PHILADELPHIA ELECTRIC COMPANY

Docket Nos. 50-277
50-278

SUBJECT: Comments on Draft Nureg-0814,
Methodology for Evaluation of
Emergency Response Facilities

FIGURE 2.1

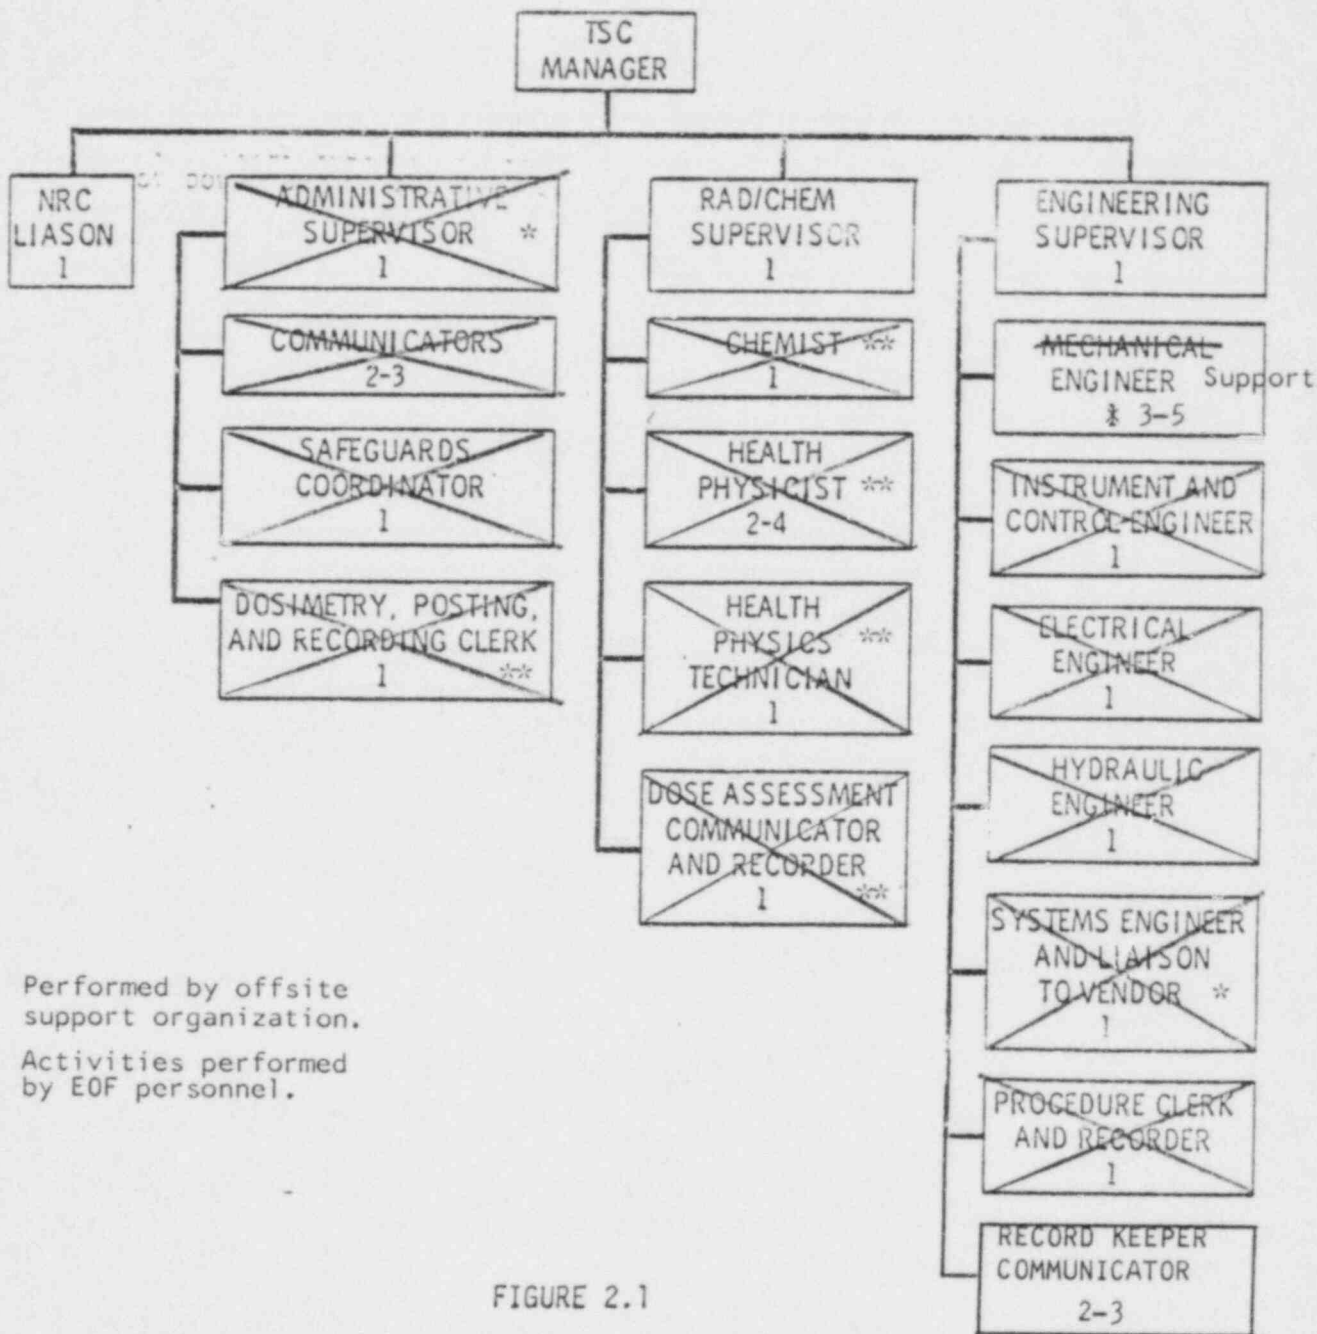
10. Organization figures 2.1 and 5.2 specifies:

- a) 20-23 personnel, and 18 positions in the TSC organization
- b) 21 personnel and 19 positions in the EOF organization

- a) 7-9 health physics and chemistry personnel are proposed for the TSC. Unlike the EOF, the TSC is not primarily involved with dose assessment and other health physics activities. Many of these positions should be deleted from the proposed organization.
- b) The number of personnel and positions proposed for both organizations is excessive. There is not enough personnel to staff the TSC/EOF around the clock in 8 hour shifts when considering the control room and offsite support requirements.
- c) The organization identifies many positions by academic discipline; i.e., mechanical, electrical, hydraulic engineer. This does not reflect the accepted practice

for staffing nuclear facilities. Nuclear plants are staffed by personnel with diverse engineering and technical backgrounds, and are assigned responsibilities related to the major areas of activity; i.e., operations, maintenance, health physics, chemistry, technical engineering support, etc. Fewer positions, with more personnel in a general staff category, would be more appropriate for the emergency facilities. The positions should be patterned after the normal plant organization and recognize the essential tasks to be performed.

- d) The proposed organizations do not acknowledge the pre-arranged support from outside consultants; i.e., Radiation Management Corporation, General Electric Company, INPO, etc.

See comment 10 in attached letter

FIGURE 5.2

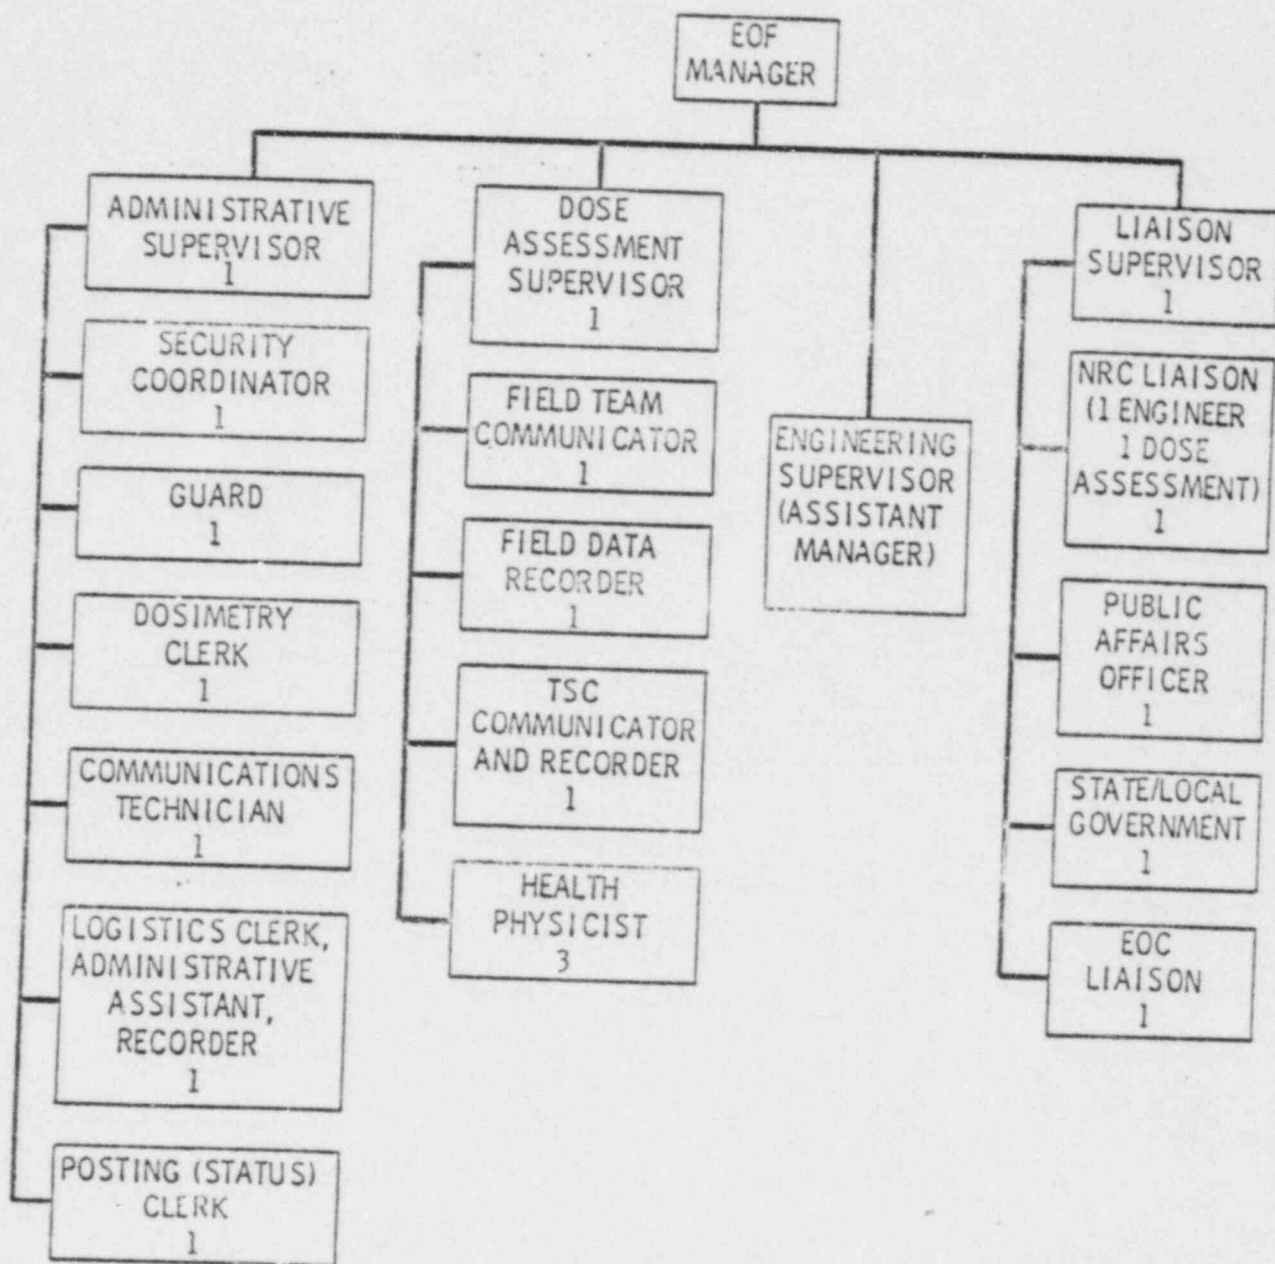
See Comment 10 in attached letter

Describe the organizations of the ~~work stations~~. Are they organized according to Figure 5.2?

See comment 10 in attached letter.
